UNITED STATES
NUCLEAR REGULATORY COMMISSION
WASHINGTON, D.C. 20555-0001

SUBJECT: PEACH BOTTOM ATOMIC POWER STATION, UNITS 2 AND 3 - ISSUANCE OF AMENDMENTS RE: MAXIMUM EXTENDED LOAD LINE LIMIT ANALYSIS PLUS (CAC NOS. MF4760 AND MF4761)

- SE Section 3.1 provides an overview of the PBAPS MELLLA+ SAR (i.e., GEH report NEDC-33720P, Revision 0, "Safety Analysis Report for Peach Bottom Atomic Power Station Units 2 & 3 Maximum Extended Load Line Limit Analysis Plus," contained in Attachment 4 to the application dated September 4, 2014).
- SE Section 3.2 discusses topics that were dispositioned generically for PBAPS in the SAR by the licensee in accordance with the M+ LTR.
- SE Section 3.3 discusses topics that were dispositioned on a plant-specific basis for PBAPS in the SAR by the licensee in accordance with the M+ LTR.
- SE Section 3.4 provides NRC staff evaluations of various topics in accordance with the guidance in RS-001.

Figure 3.1-1 - MELLLA+ Operating Domain for PBAPS

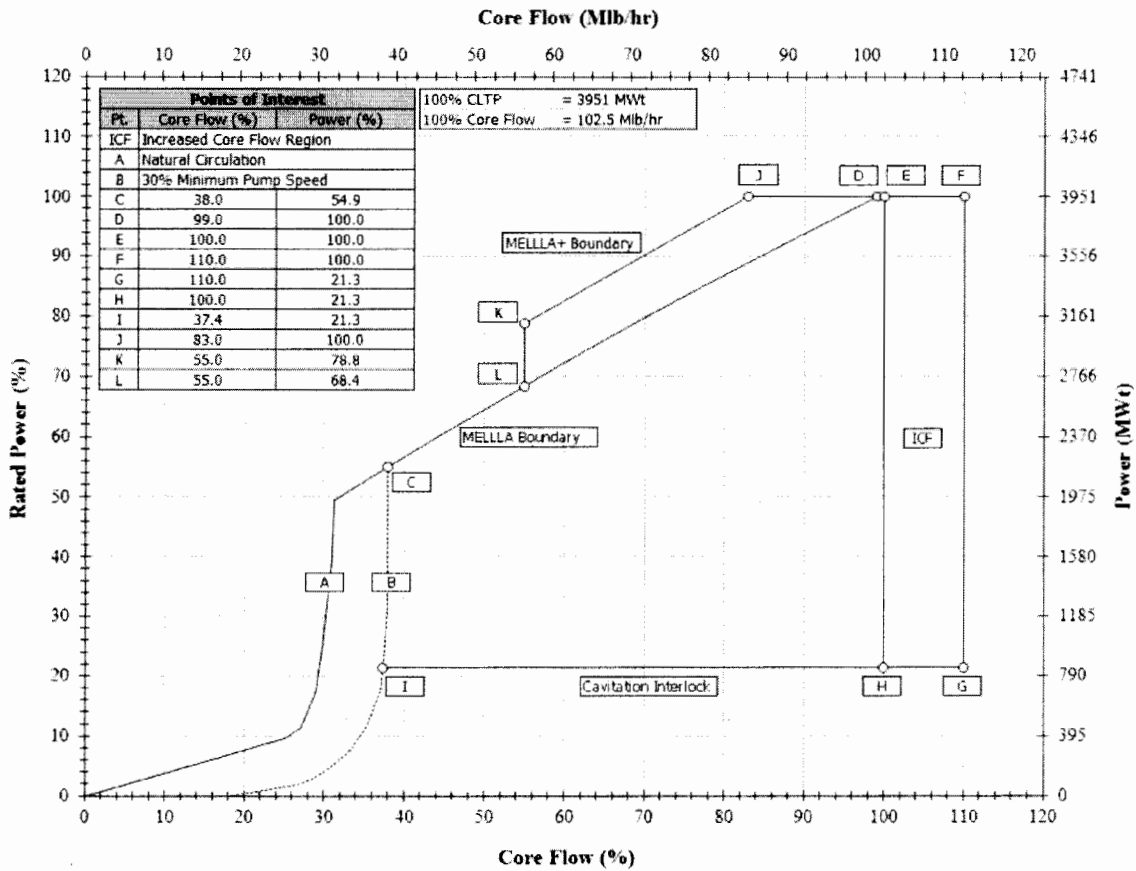
As discussed in SAR Section 2.2.1, as required by the M+ LTR Limitation and Condition 12.6, the SLMCPR is calculated at Statepoints E, J, K, and F (shown in Figure 3.1-1 of this SE). In addition, uncertainties for SLO are applied to Statepoints J and K. The calculated values will be documented in the SRLR.

At the MELLLA+ low corner (Point K of Figure 3.1-1), the power-to-flow ratio is maximized and there is the potential to encounter void formation in the bypass region. The NRC staff requested that the licensee determine the effect of bypass void formation on local power range monitors (LPRMs) and traversing incore probes (TIPs). The licensee's evaluation concluded that no bypass voiding is expected at the highest TIP elevation that corresponds to the highest LPRM detector elevation. This value is calculated using the ISCOR hot channel methodology, which is conservative, because it neglects cross flow between bundles in the bypass region.

- 12.23.5 – The PBAPS power density at the full power-minimum flow statepoint in the MELLLA+ operating domain (Point J of Figure 3.1-1) is 46.4 MWt/Mlbm/hr, which does not exceed the 52.5 MWt/Mlbm/hr limit.

The power-flow map (SAR Figure 1-1) shows Point F with 110% flow in the increased core flow (ICF) region. What is the maximum core flow that PBAPS can achieve? Is this a function of exposure (e.g., bottom-peaked shapes may result in reduced max achievable flow)? Is PBAPS susceptible to bi-stable flow in the recirculation loops? If so, what is the maximum (or range of) achievable recirculation flow used in normal operation to minimize bi-stable flow concerns?

Figure A-1 - Illustration of SLMCPR adders

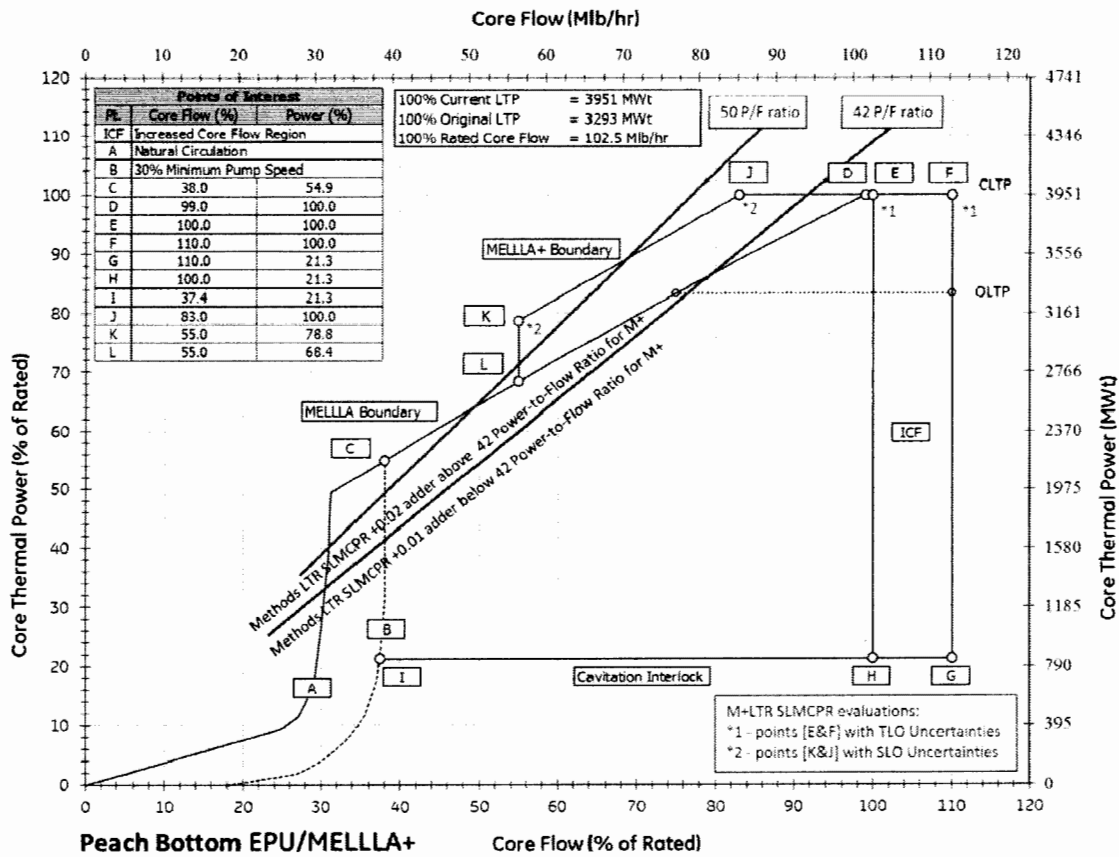
The licensee provided an illustration of the SLMCPR adder used as show in Figure A-1. For points J and K, which lie inside the MELLLA+ region, single loop operation (SLO) uncertainties are used. For Points F, E, D, and L, two loop operation (TLO) uncertainties are used. For all points, the Methods +0.02 adder is used conservatively, even though a value of +0.01 could have been used for points F, E, and D because they lie under the 42 MWt/Mlbm/hr line.

Conservative application of the +0.02 adder is acceptable because it will establish the most limiting SMCP values in the Technical Specifications. This RAI is closed.

Figure A-4 - Turbine Trip Feedwater Temperature Reduction

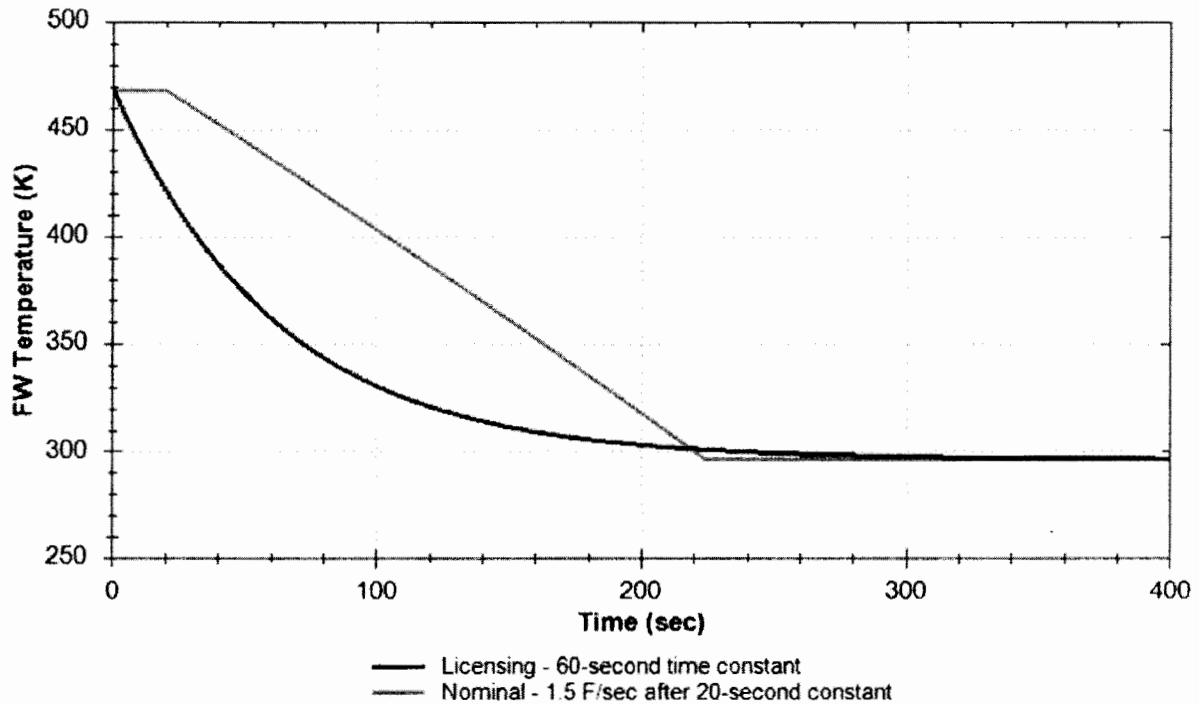
1. Feedwater cooling rate. Two cooling rates were used for the analysis:
 - a. A licensing case, where a 60 second exponential time constant is used to reduce feedwater temperature from nominal to condenser temperature.
 - b. A nominal case based on training simulator modeling where the cooling rate of 1.5°F/second is assumed following 20 seconds of the temperature remaining constant, which results in a slower cooling rate (see Figure A-4).
2. Operator action timing:
 - a. 90 seconds, 120 seconds, and 200 seconds to initiate feedwater flow reduction.
3. Hot rod peaking factor:

The licensee provided the requested sensitivity calculations. Tables 1 and 2 of the RAI response (reproduced here, in part, as Tables A-2 and A-3) summarize the PCT results of TTWBP-ATWSI sensitivity calculations.
